HIE's proposals to smooth and regrade land at Cairn Gorm

This post takes a further look at the issues ([see here](#)) associated with the latest Planning Application (2019/0247/DET) by Highlands and Islands Enterprises/ Cairngorm Mountain Scotland Ltd at Cairn Gorm. The application is to create a beginners ski area over an area of 0.93 ha or 9,300 sq.m. in the lower right-hand half of the picture above ([see here for planning documents](#)).

Section through Areas K
Plan to Scale 1 : 200

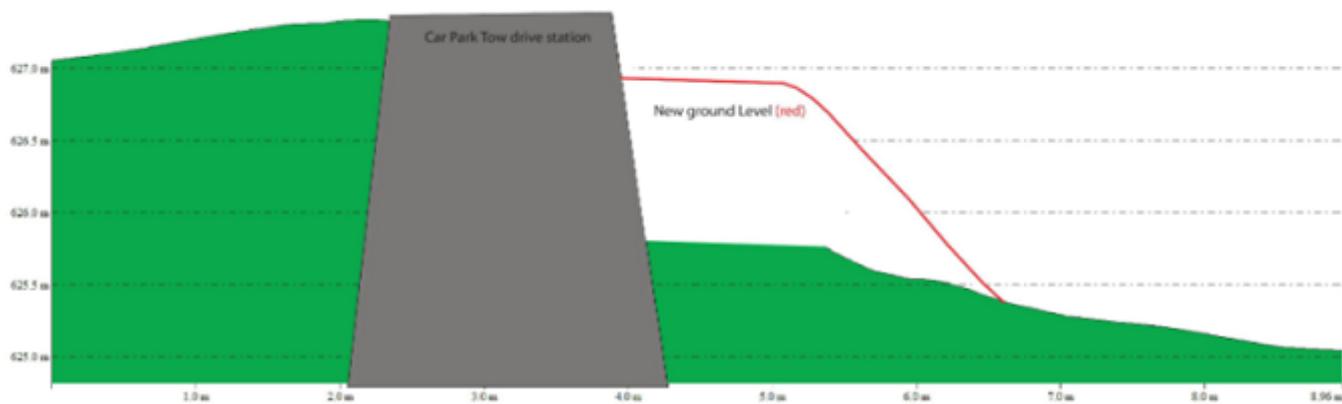
Area K is by the car park lift station

(6) Area K in the application has nothing to do with a beginners slope. It is about the safety of employees working on the Carpark drive station, which must be a priority, although it does look as though it could be just a convenient dumping point for unused materials from the bulldozing. It raises the question that if this was part of the Health & Safety Executive investigation from 06/12/2018, why has it not been actioned before now?
